Subject: **MHI's Response to US-APWR DCD RAI No. 919-6392 Revision 0 (SRP 09.02.02)**

US-APWR Design Certification

RAI NO.:	**NO. 919-6392 REVISION 0**
SRP SECTION:	**09.02.02 – Reactor Auxiliary Cooling Water Systems**
APPLICATION SECTION:	**09.02.02**
DATE OF RAI ISSUE:	**4/10/2012**

QUESTION NO.: 09.02.02-86

Figure 2.7.3.3-1 Component Cooling Water System (Sheet 1 of 2)

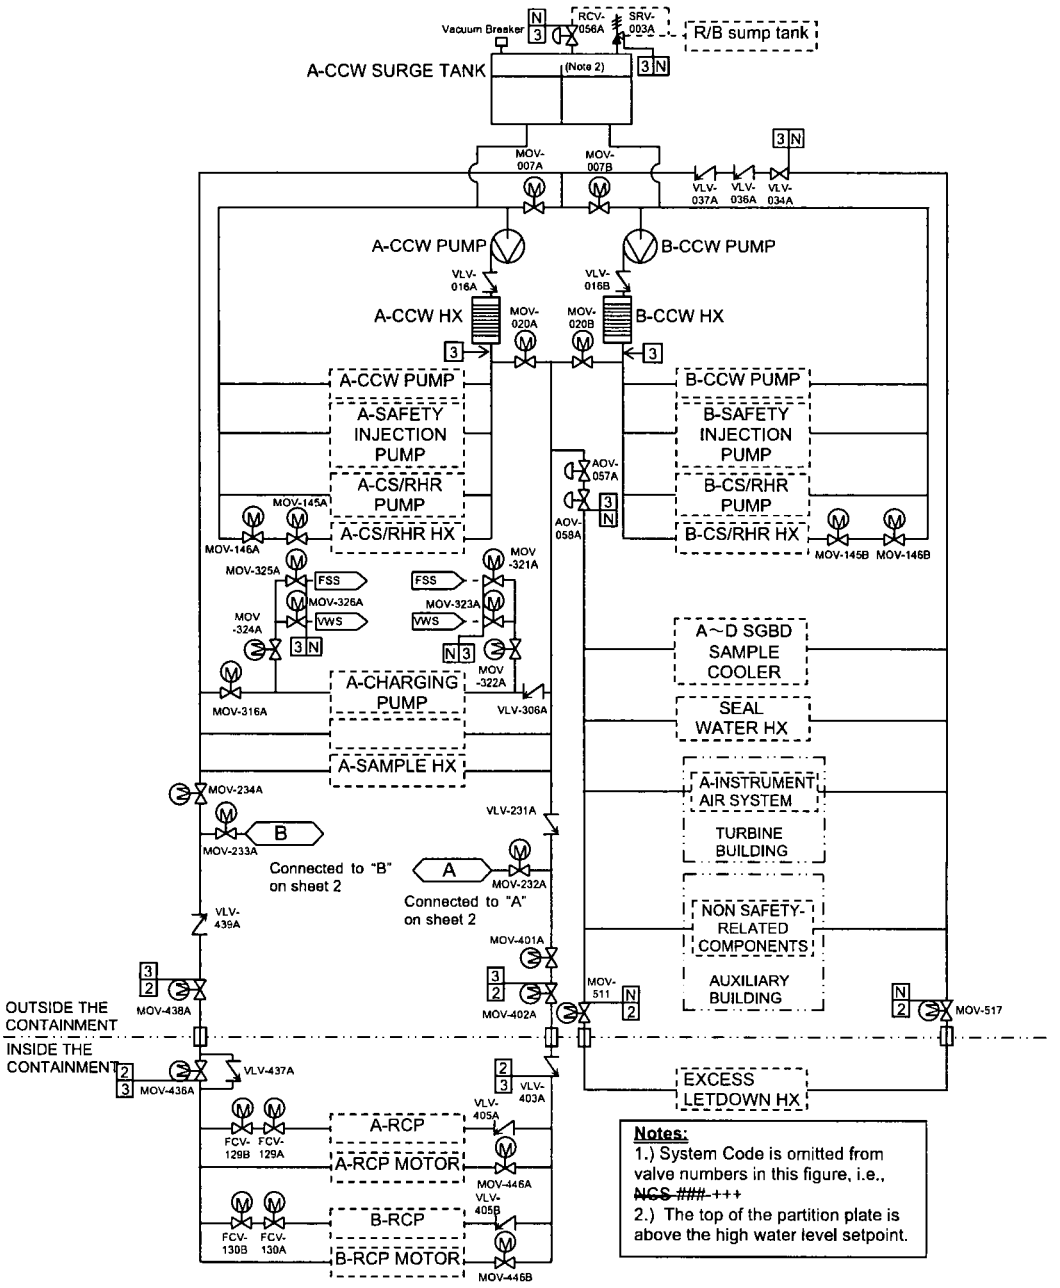
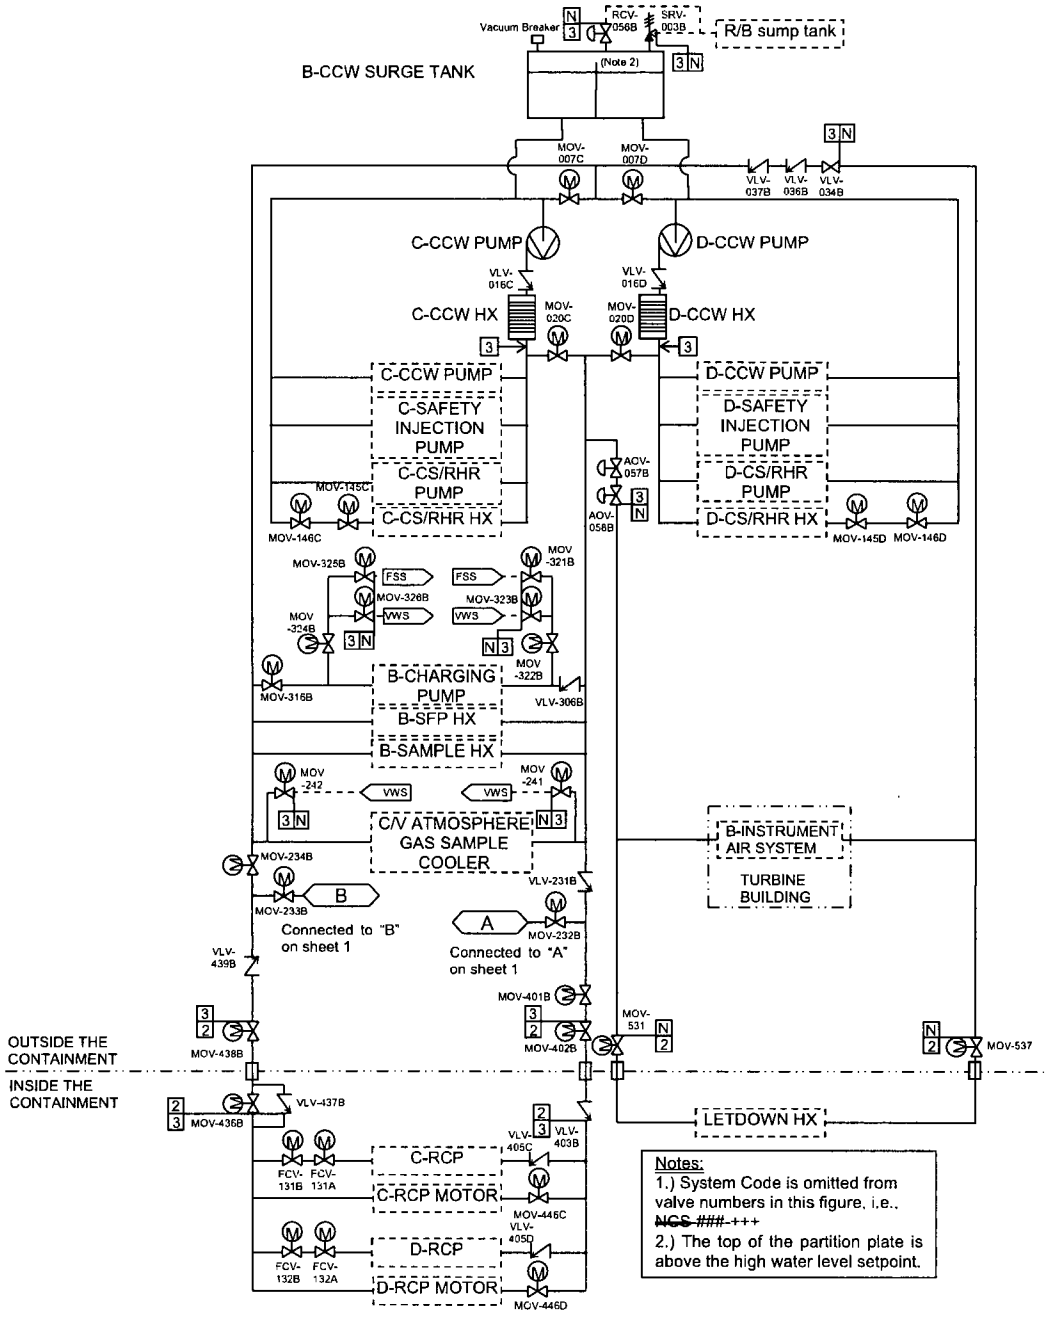
1. The applicant should revise its application and RAI response to address all potential scenarios due to the MOVs train cross tie valves (MOV-007s and 020s) being open. This one example above may not be limiting.
2. The Tier 2 Failure Modes and Effects Analysis (FMEA) should be revised to address various and most limiting single active failures, as described in item 1.

- Table 2.7.3.3-2: Add "CS/RHR heat exchanger CCW outlet 2nd valves", isolation valves MOV-146A, B, C and D.
- Table 2.7.3.3-2: Change the name of MOV-145A, B, C and D from "CS/RHR heat exchanger CCW outlet valves" to "CS/RHR heat exchanger CCW outlet 1st valves."
- Table 2.7.3.3-2: Add "Low CCWP discharge pressure" and "Transfer Closed" to "PSMS Control" and "Active Safety Function," respectively of MOV-145A, B, C and D.
- Table 2.7.3.3-2: Add pressure instruments PT-025, 026, 027,028, 035, 036, 037 and 038.
- Table 2.7.3.3-4: Add the isolation valves MOV-146A, B, C and D.
- Table 2.7.3.3-4: Change the name of MOV-145A, B, C and D from "CS/RHR heat exchanger CCW outlet valves" to "CS/RHR heat exchanger CCW outlet 1st valves."
- Table 2.7.3.3-4: Add pressure instruments (PT-025, 026, 027, 028, 035, 036, 037 and 038.
- Figure 2.7.3.3-1: Add isolation valves (MOV-146A, B, C and D).
